PROJECT DETAILS – TELL US ABOUT YOUR PROJECT

PRINCIPAL FACADE

ARCHITECTURAL SURVEY	
VERSION 1	01
3747 Tyler Detroit	
PRINT A2 (16,5 x 23,375)	
DATE:

BACK FACADE

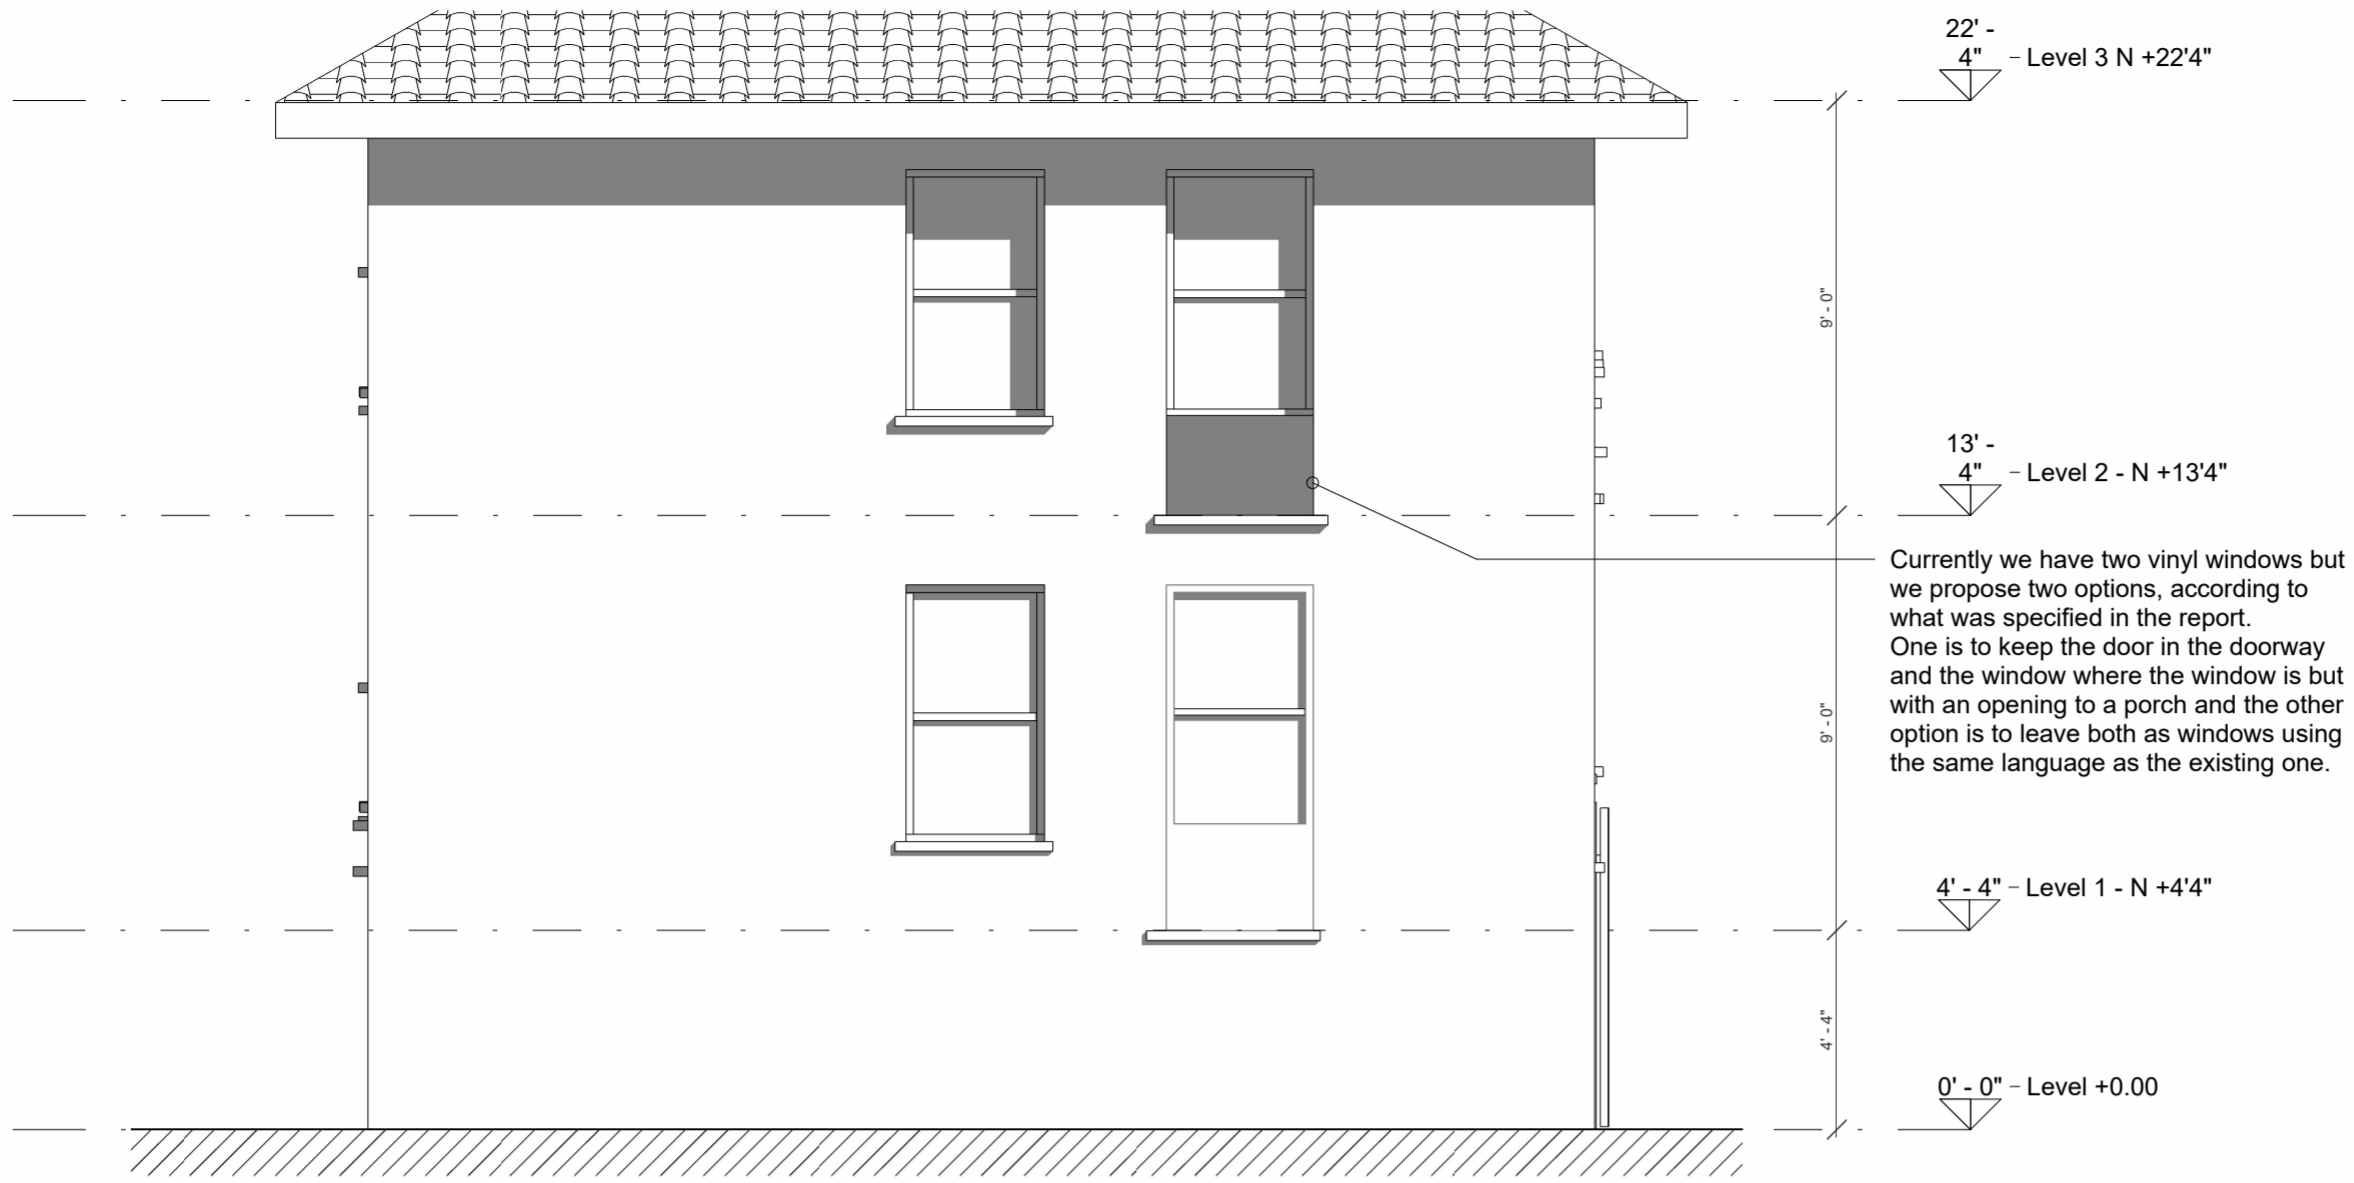
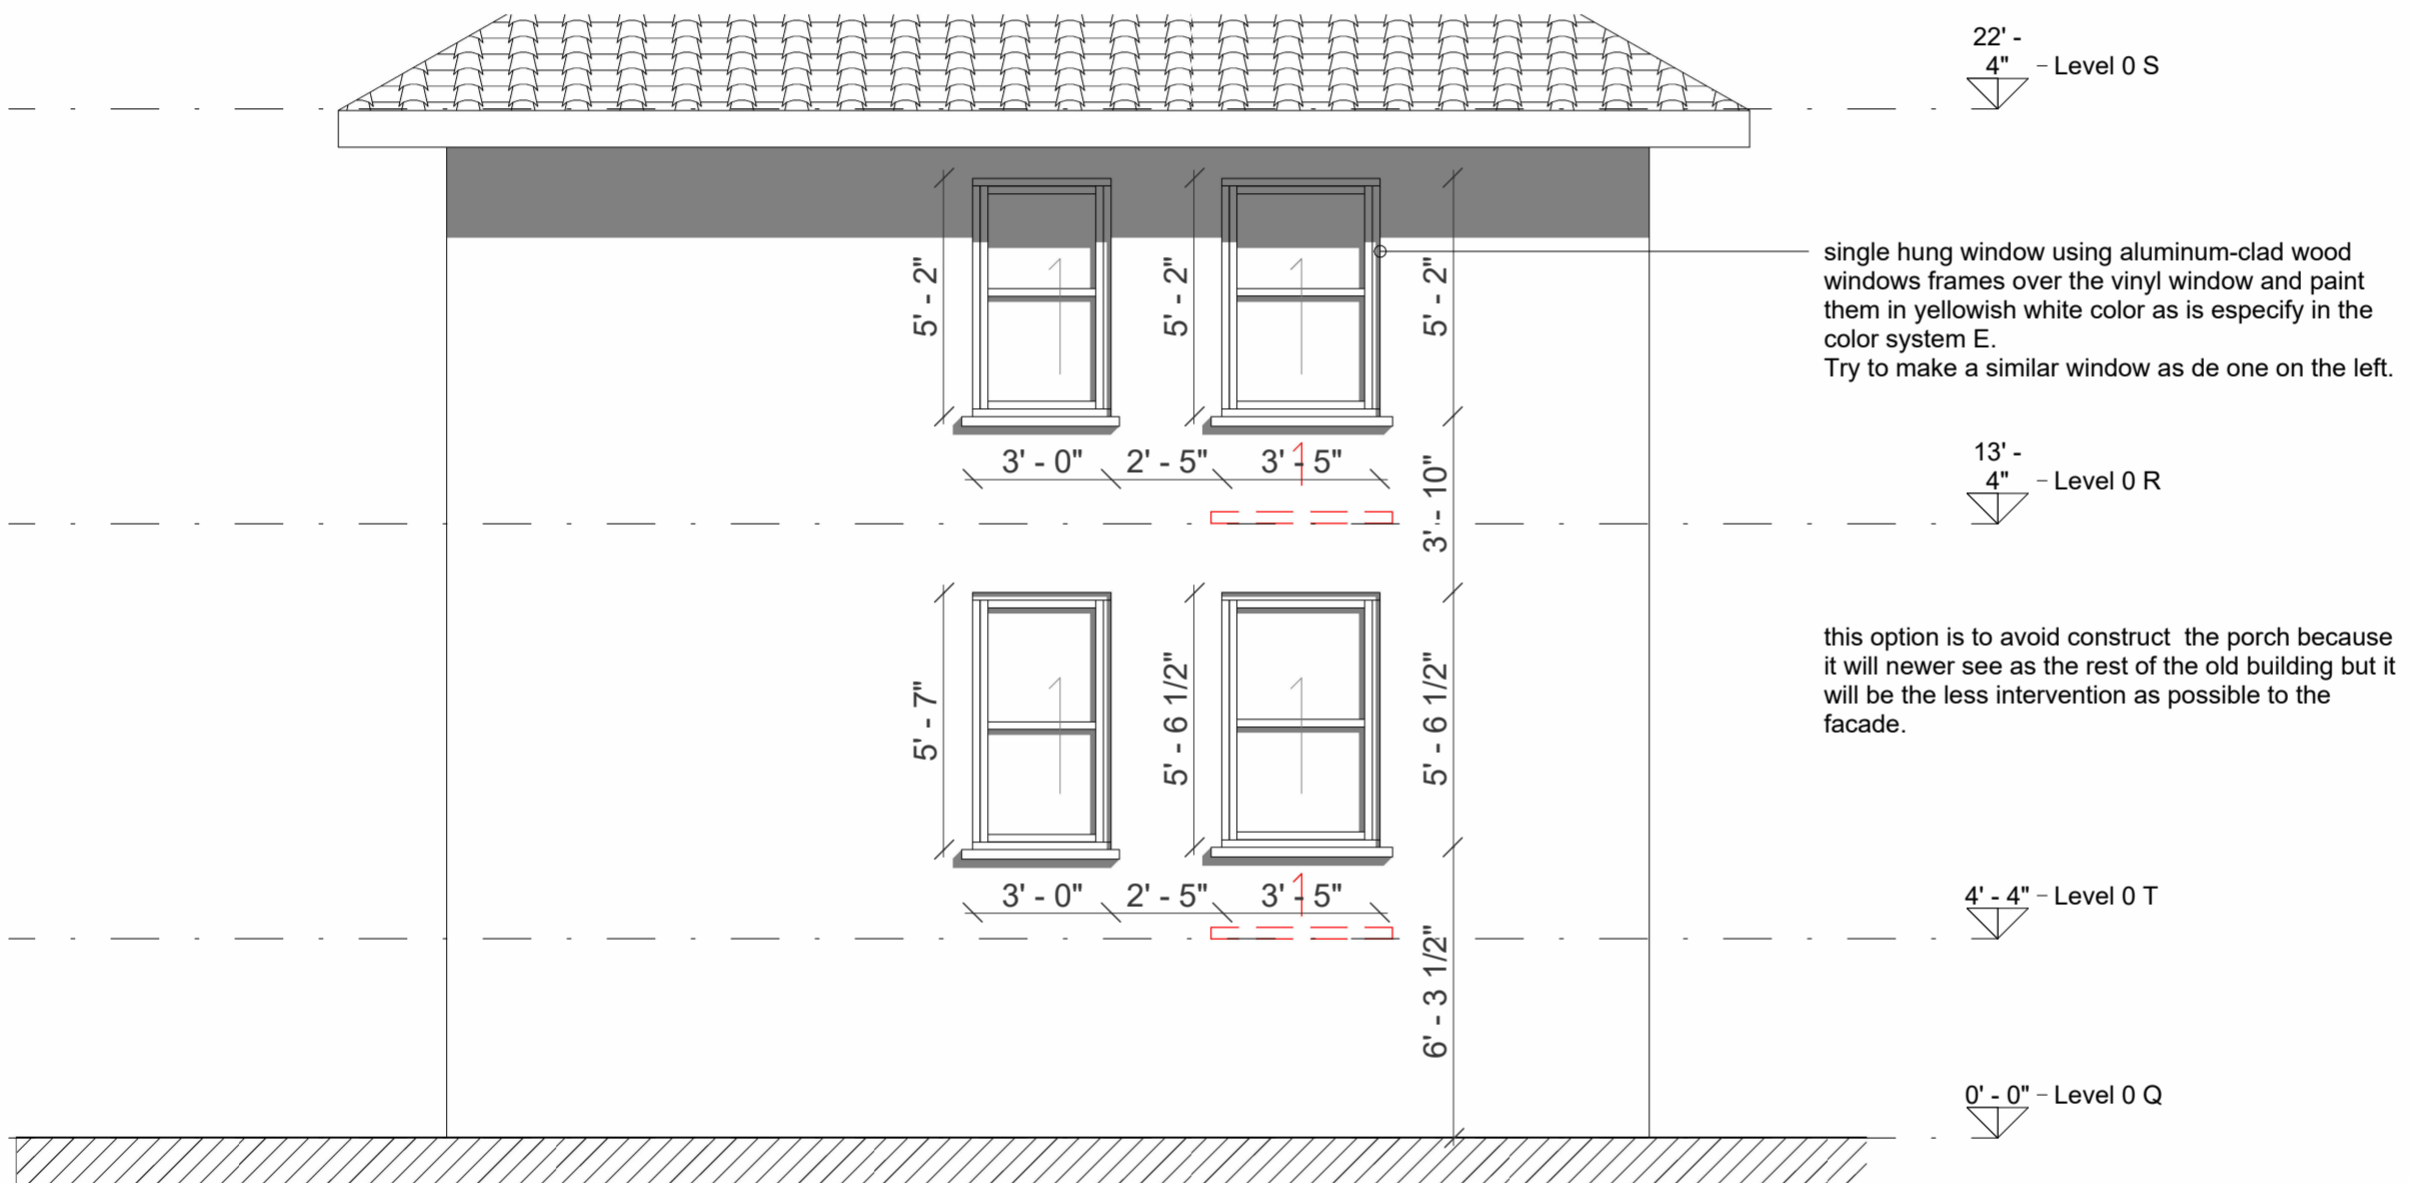
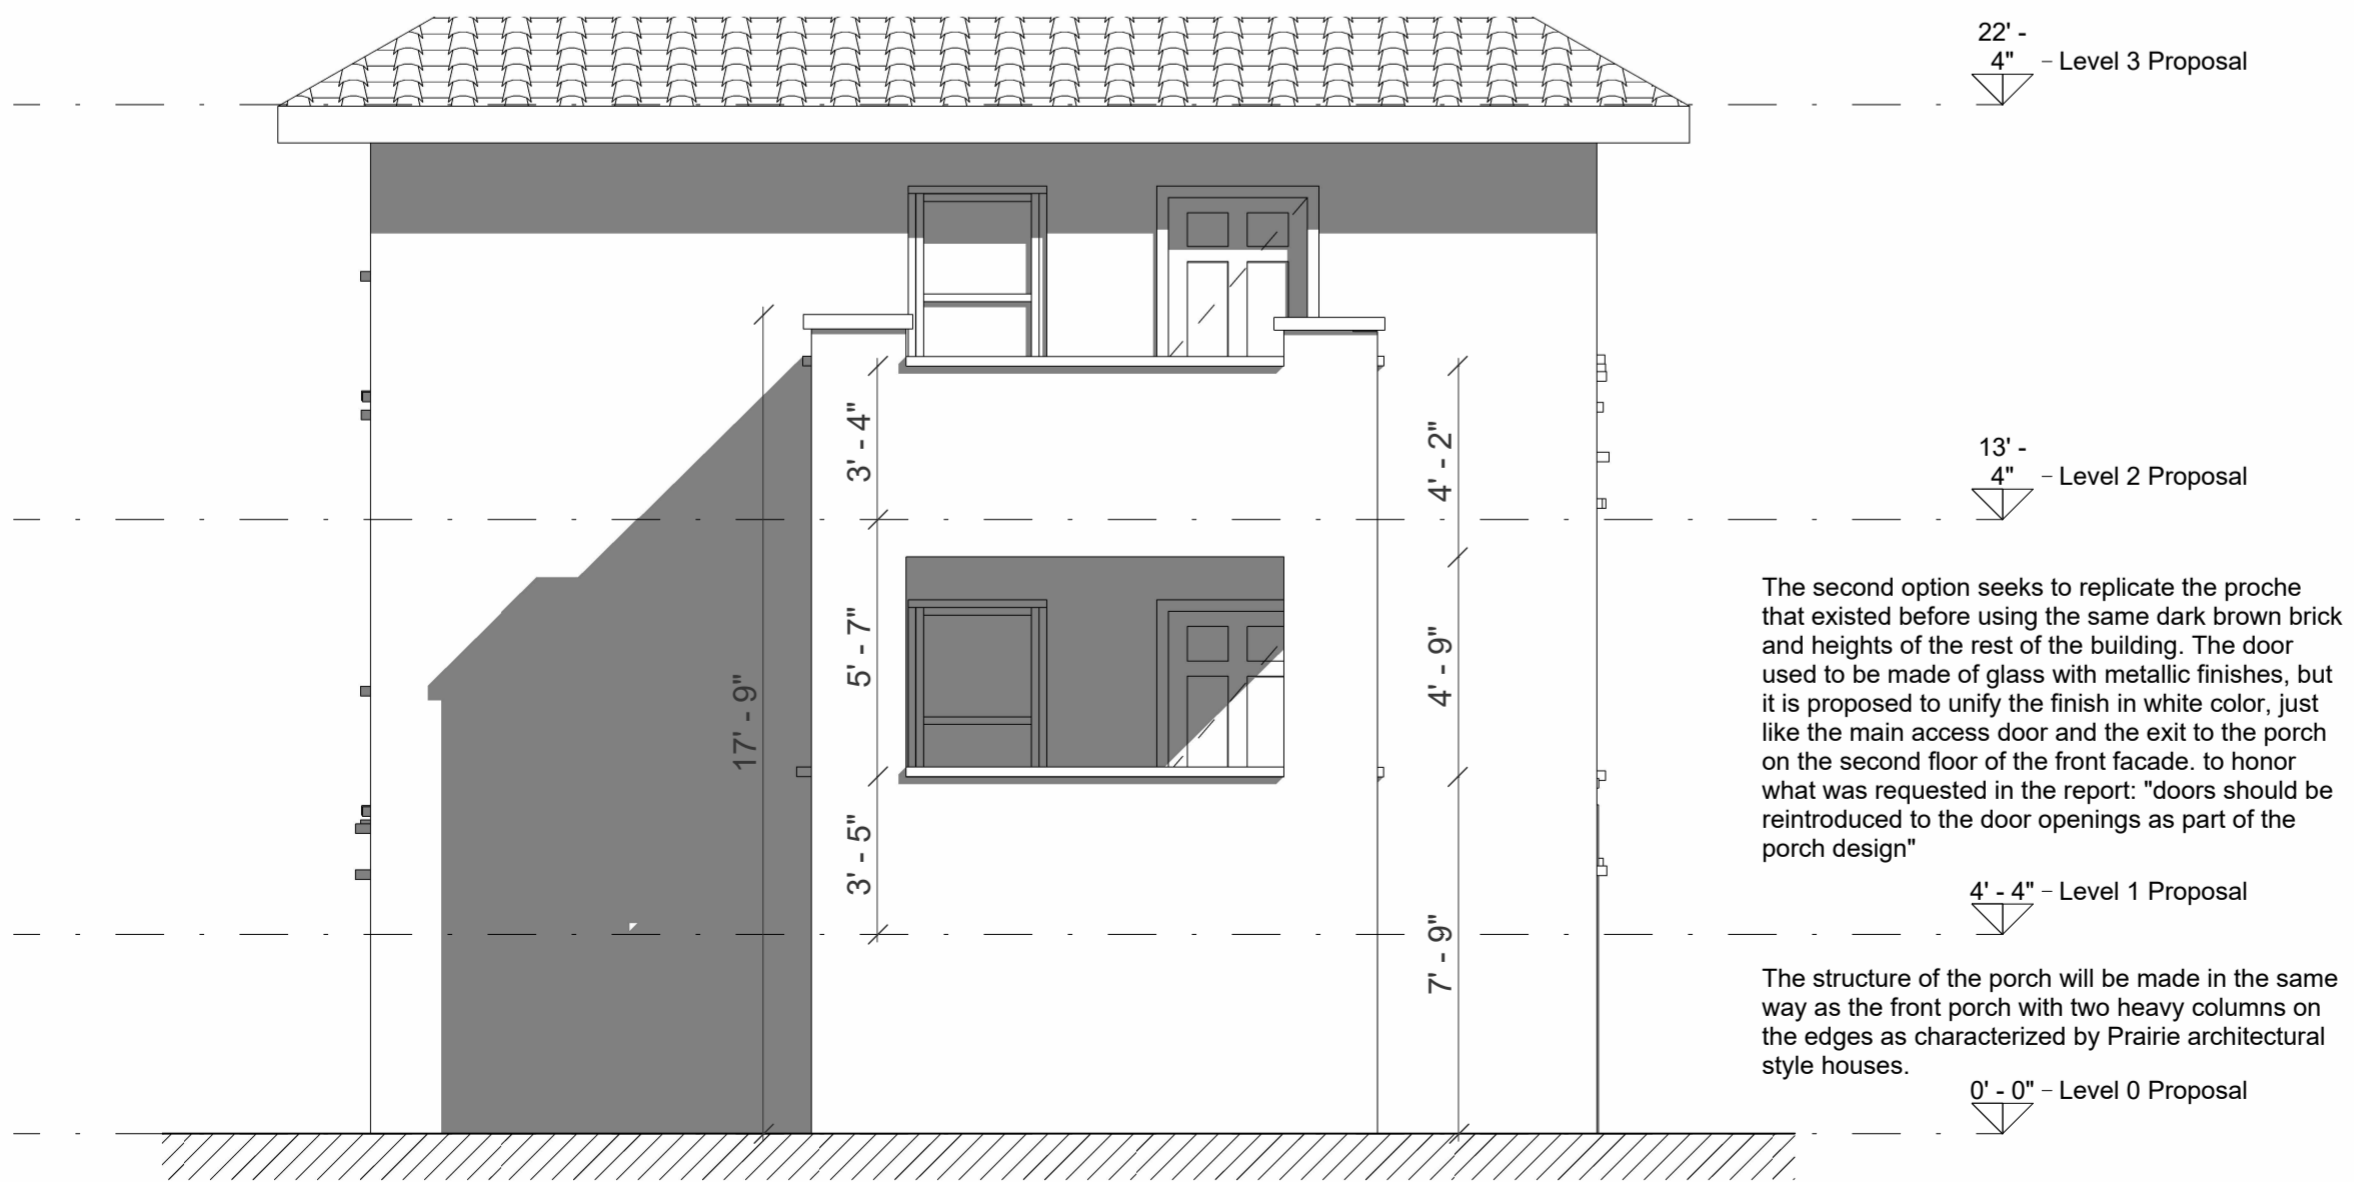
Currently we have two vinyl windows but we propose two options, according to what was specified in the report. One is to keep the door in the doorway and the window where the window is but with an opening to a porch and the other option is to leave both as windows using the same language as the existing one.

single hung window using aluminum-clad wood windows frames over the vinyl window and paint them in yellowish white color as is especify in the color system E.
Try to make a similar window as de one on the left.

this option is to avoid construct the porch because it will newer see as the rest of the old building but it will be the less intervention as possible to the facade.

The second option seeks to replicate the proche that existed before using the same dark brown brick and heights of the rest of the building. The door used to be made of glass with metallic finishes, but it is proposed to unify the finish in white color, just like the main access door and the exit to the porch on the second floor of the front facade. to honor what was requested in the report: "doors should be reintroduced to the door openings as part of the porch design"

The structure of the porch will be made in the same way as the front porch with two heavy columns on the edges as characterized by Prairie architectural style houses.
